H11022

DESCRIPTIVE REPORT

Locality Miah Maul Shoal to Ben Davis Point

**Descriptive Report to Accompany
Hydrographic Survey H11022
Scale 1:20,000, Surveyed 2001
R/V OceanExplorer
Science Applications International Corporation (SAIC)
Walter S. Simmons, Hydrographer**

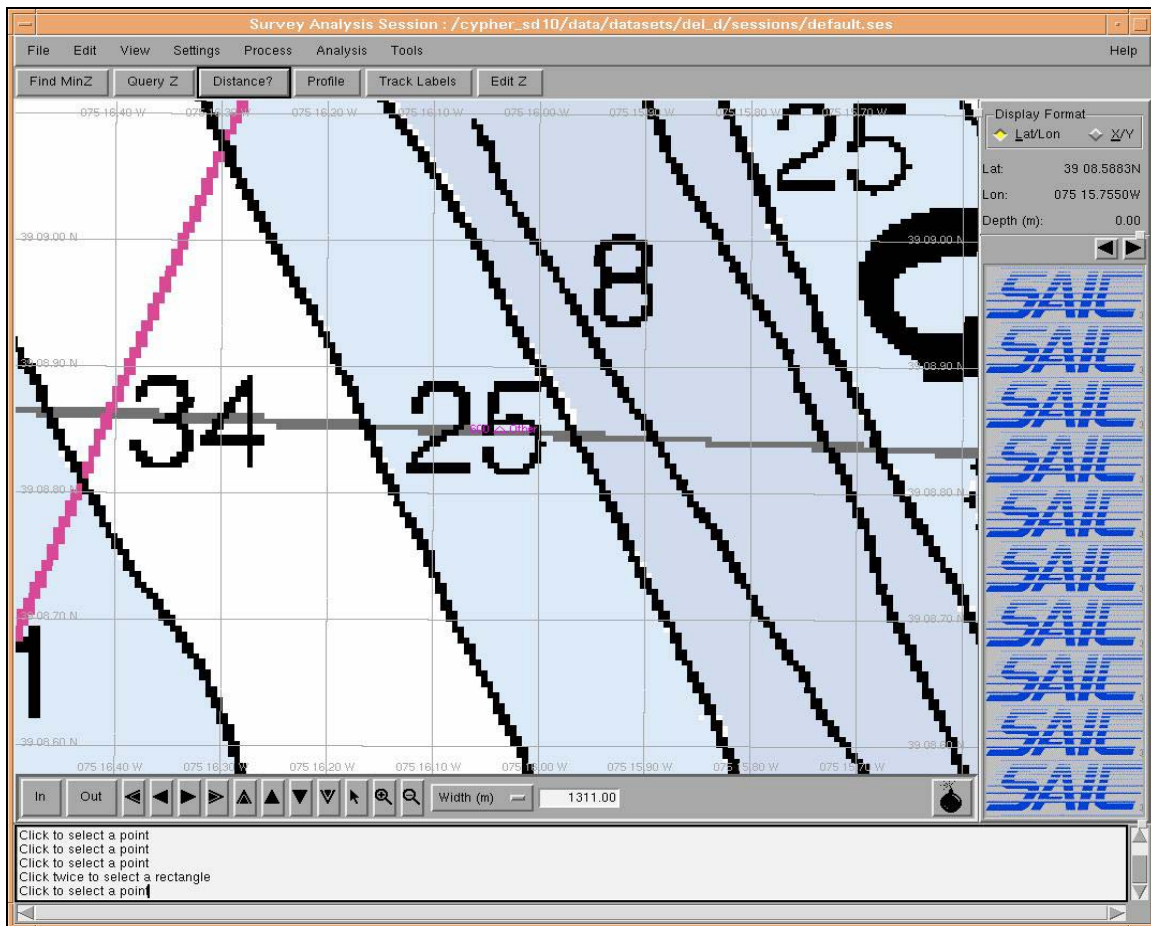
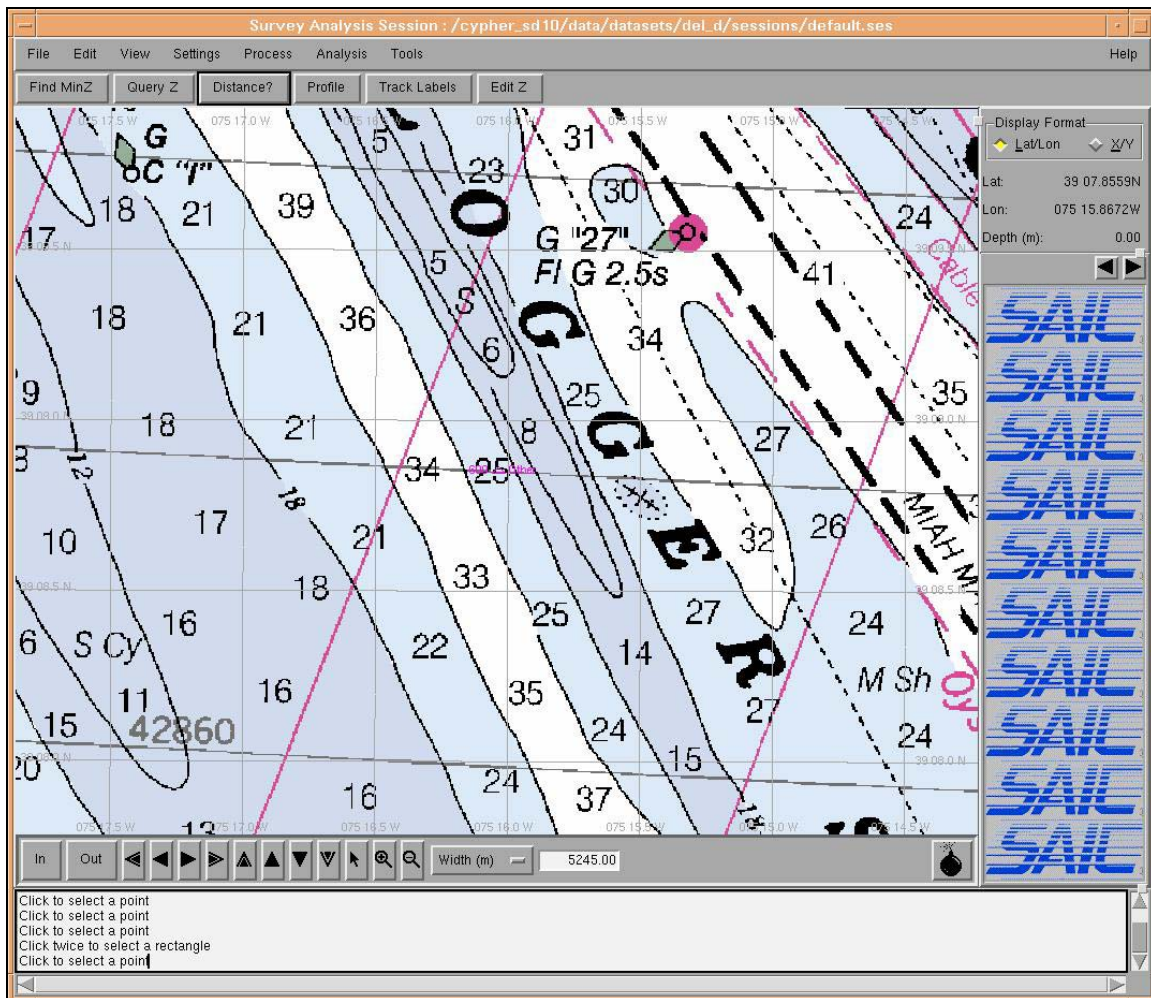
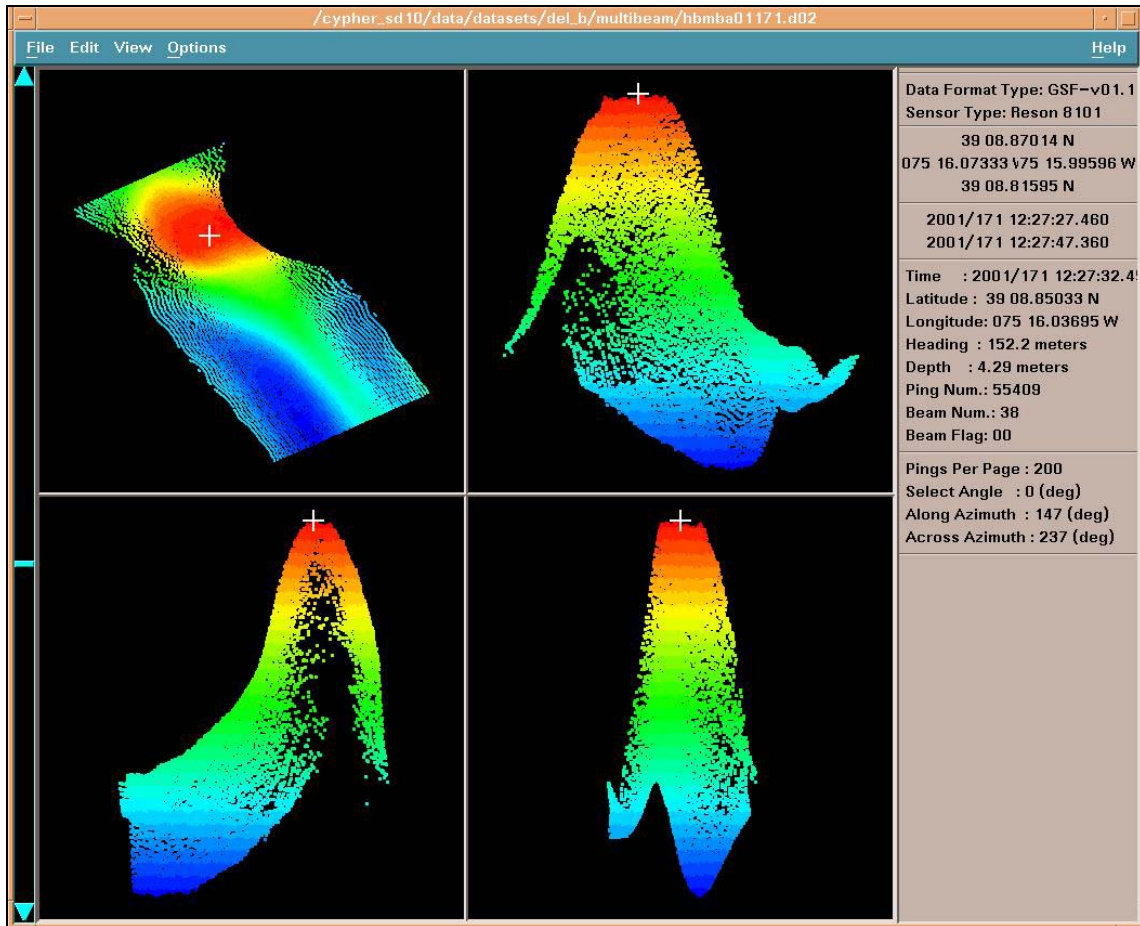
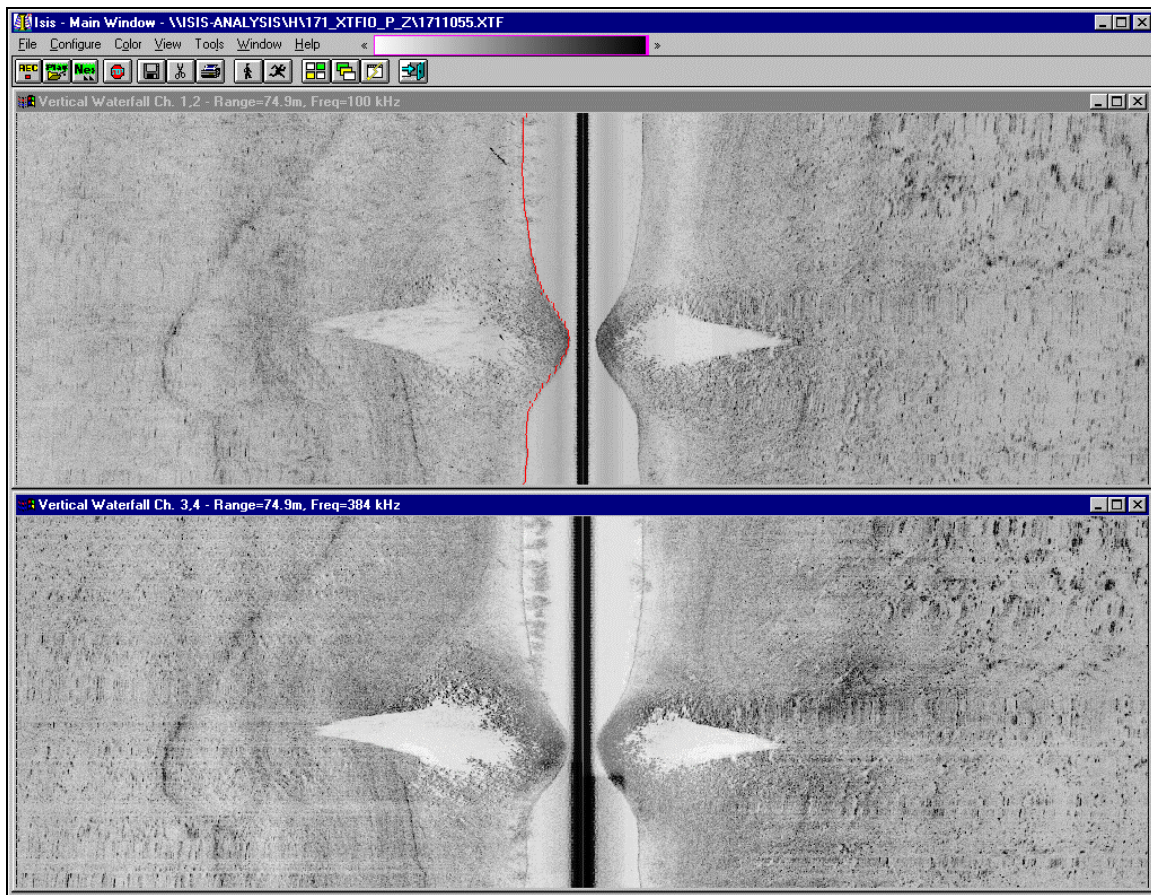
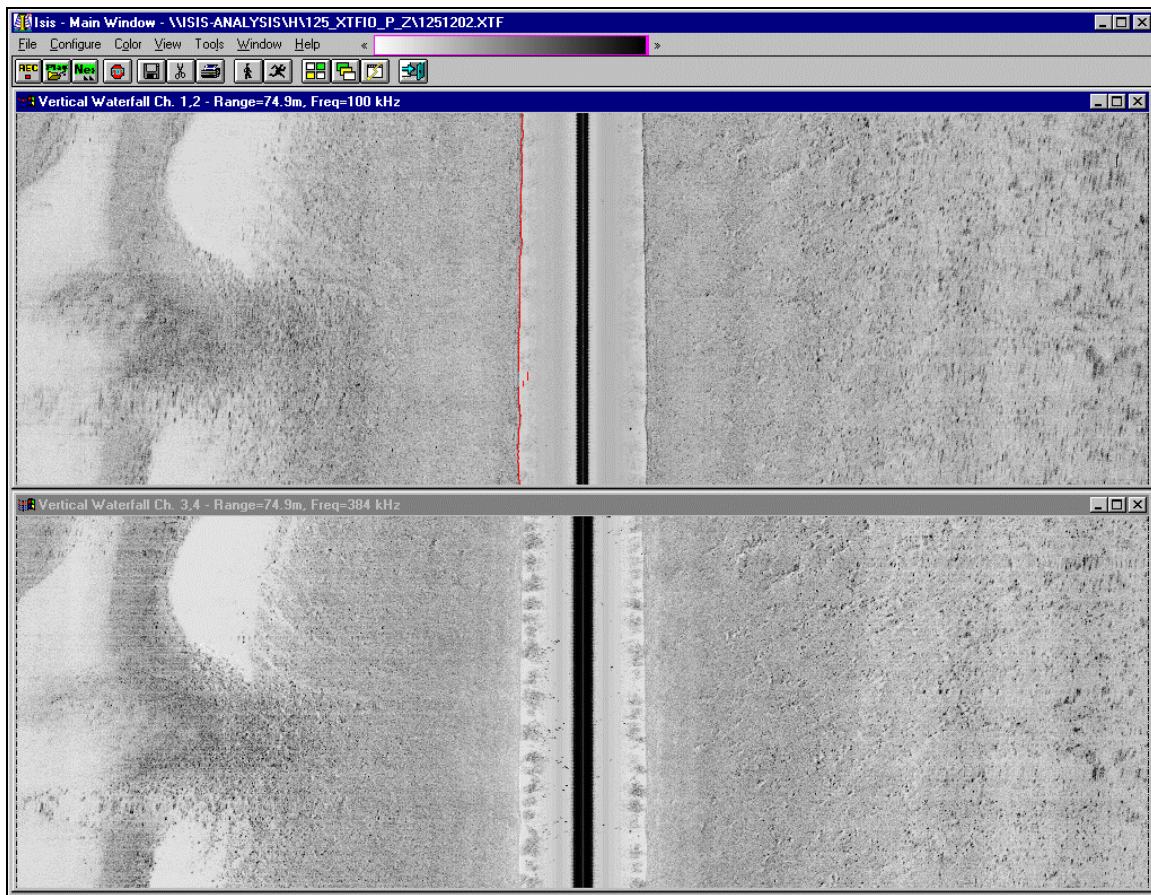
- Report 3 was submitted on or about 17 July 2001, and reported an 18 foot (4.29 meters) high obstruction with a minimum depth of 14 feet in (4.29 meters) in 25 feet (7.62 meters) of water, at 39° 08' 51.02"N 075° 16' 02.22"W, NAD83, (*See Correlator Sheet for Feature #100) (*See Chartlet 13). Recommend maintaining the charted 14 Obstn and danger circle. **Concur.**
